Subject: **Modification Request for the Individual Section 404 and Section 10 Permits, Section 401 Water Quality Certification and CAMA Major Development Permit** for the Wilmington Bypass from north of US 74/76 in Brunswick County to US 421 in New Hanover County. Federal Aid Project Nos. NHF-0017 (96) and STM-0017 (97), Division 3, TIP No. R-2633B. Debit \$475 from WBS Element 34491.1.2

R-2633B

Site 21

Permit Drawing 68 of 73
Revised 9/3/14

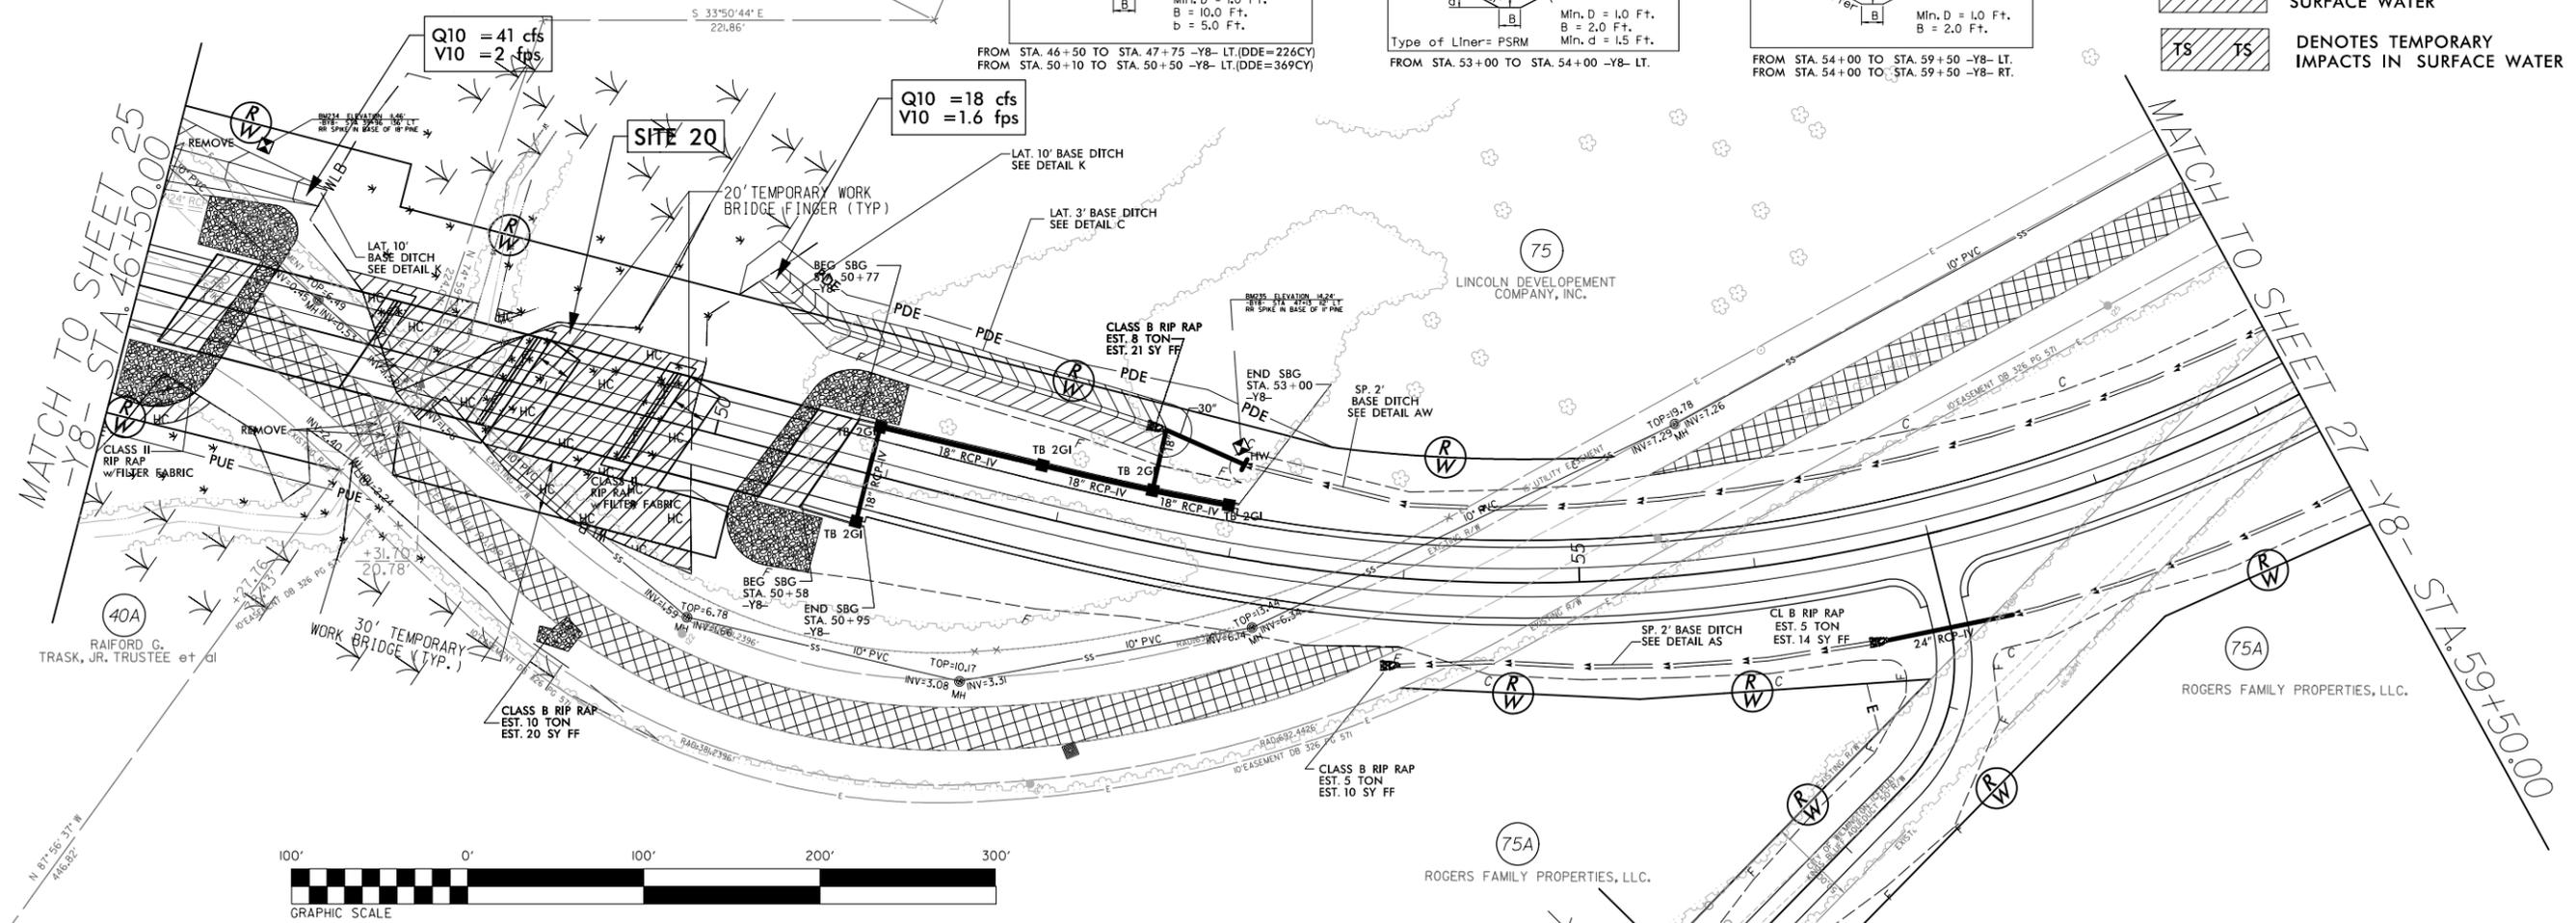
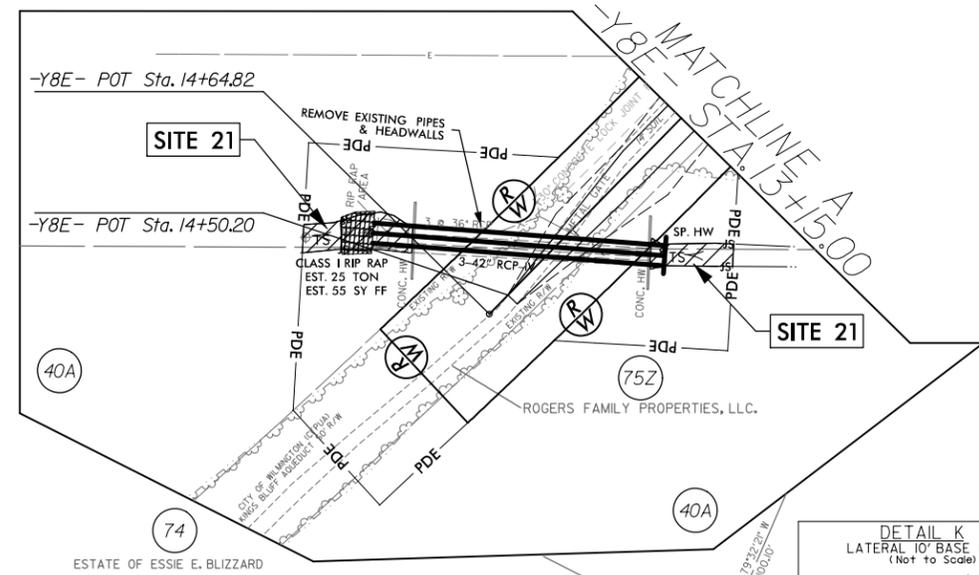
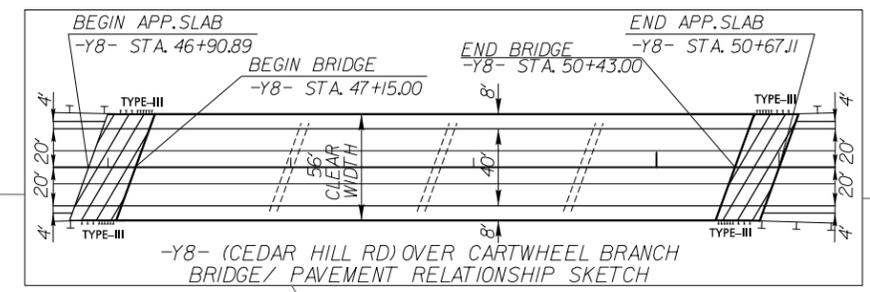
REVISIONS
CONSTRUCTION REVISION: 8/20/2014, ADDED SERVICE ROAD -Y8E-

Permit Drawing 69 of 73
Revised 9/3/14

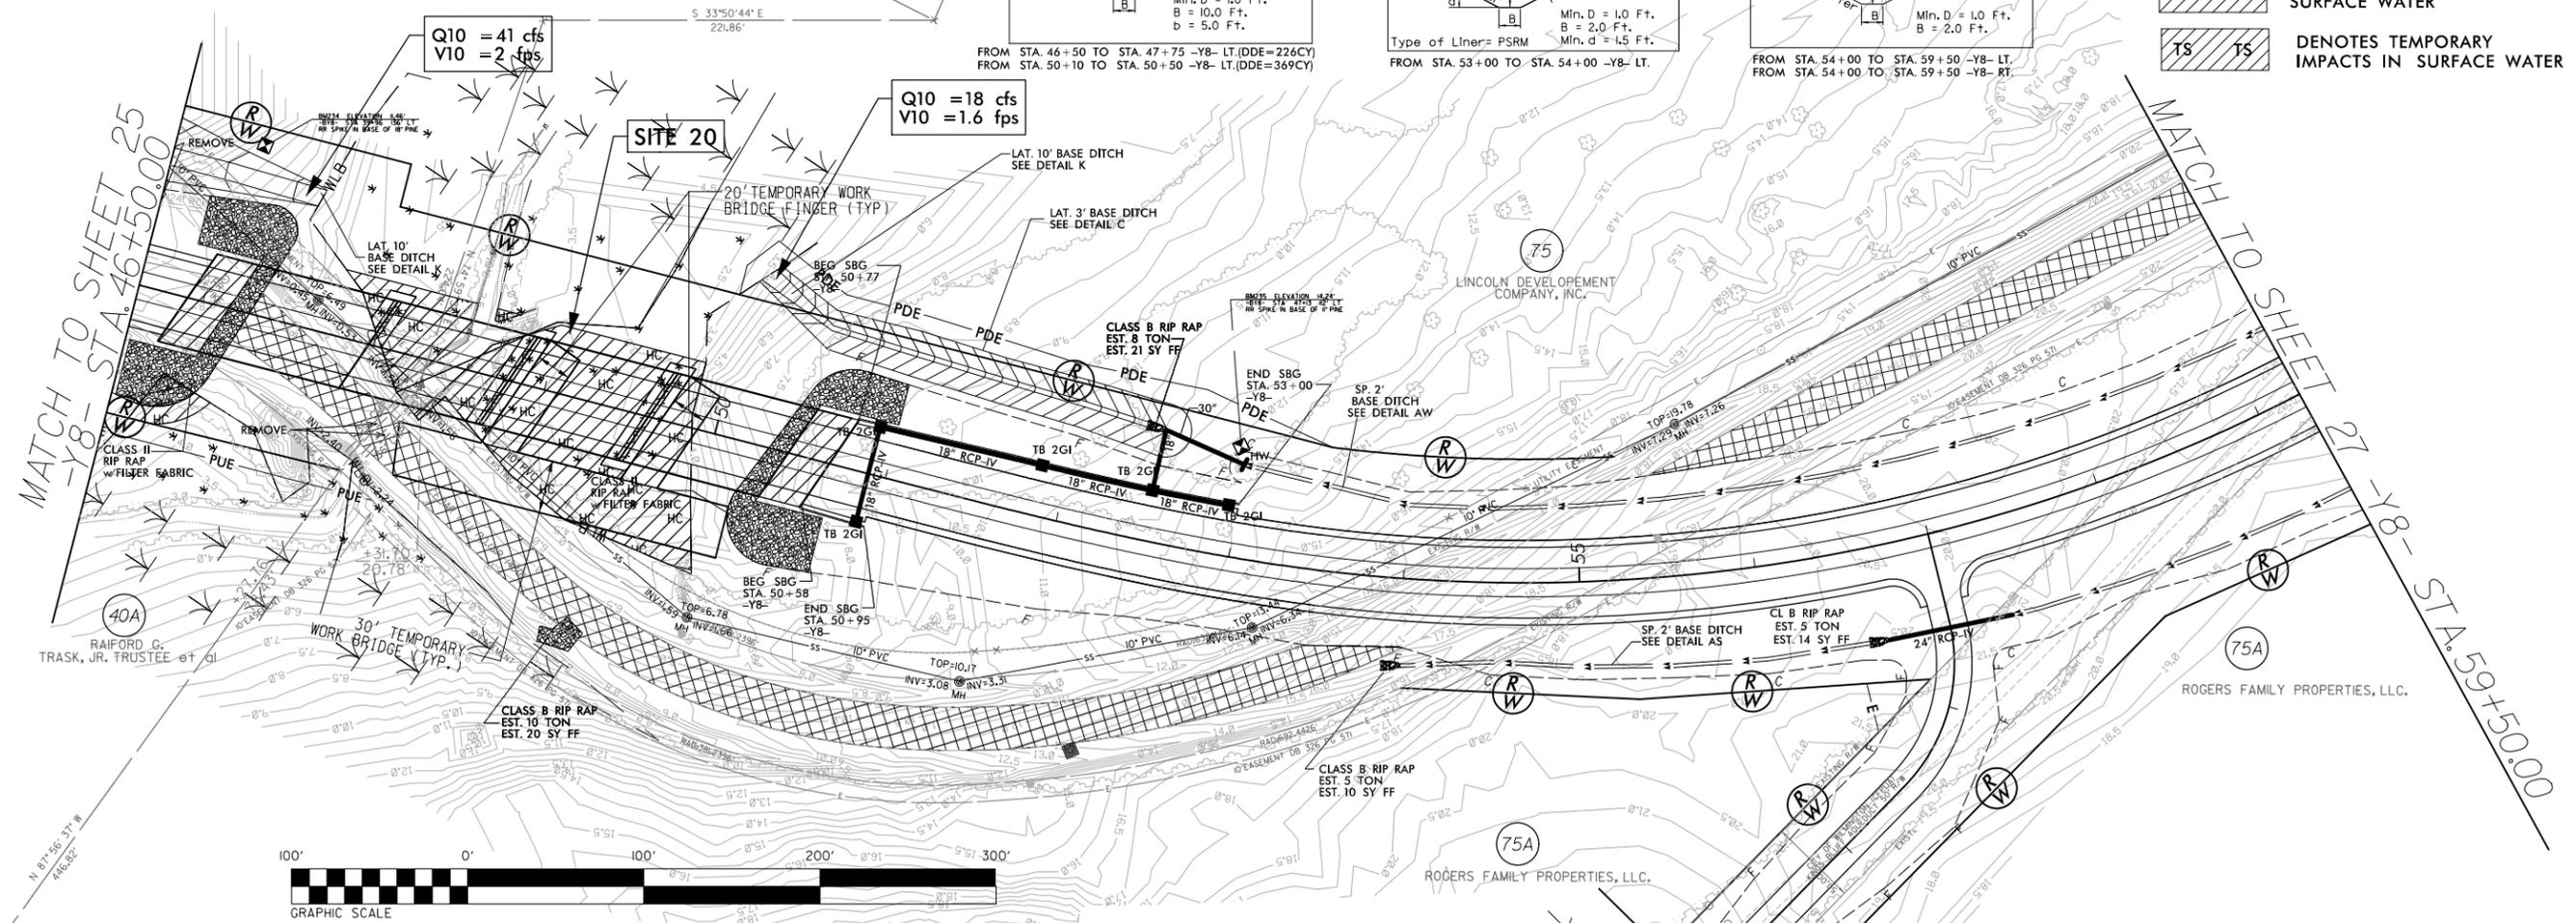
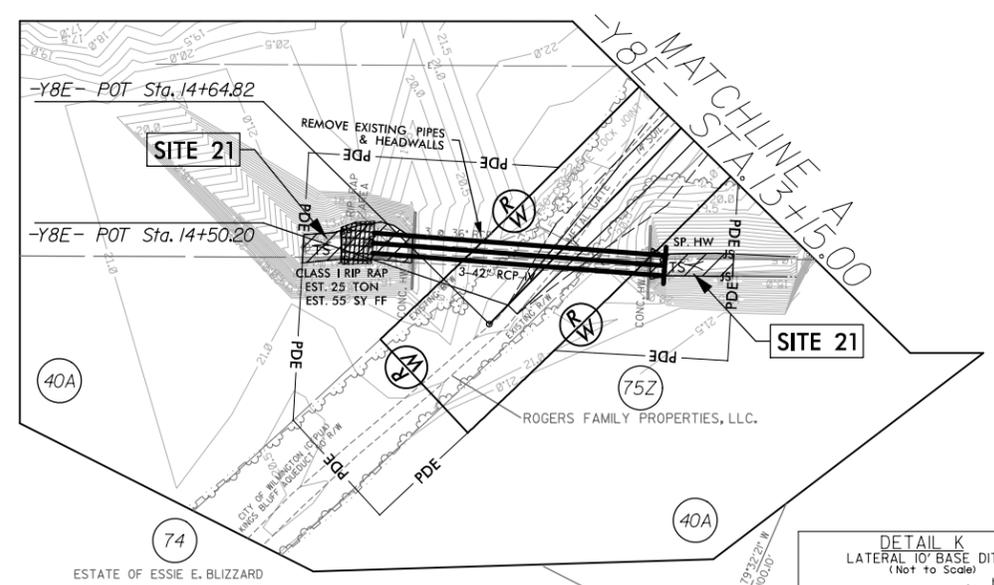
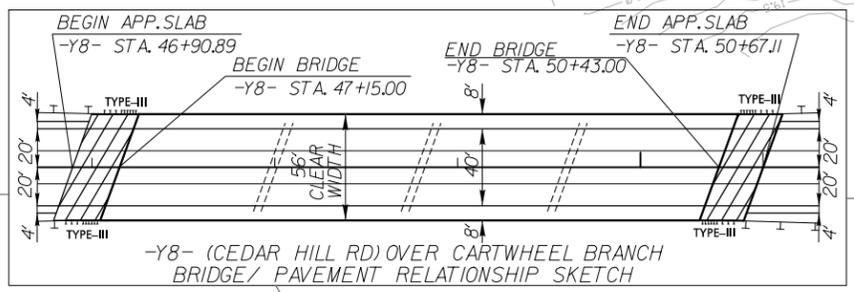
REVISIONS
 CONSTRUCTION REVISION: 8/20/2014, ADDED SERVICE ROAD -Y8E-
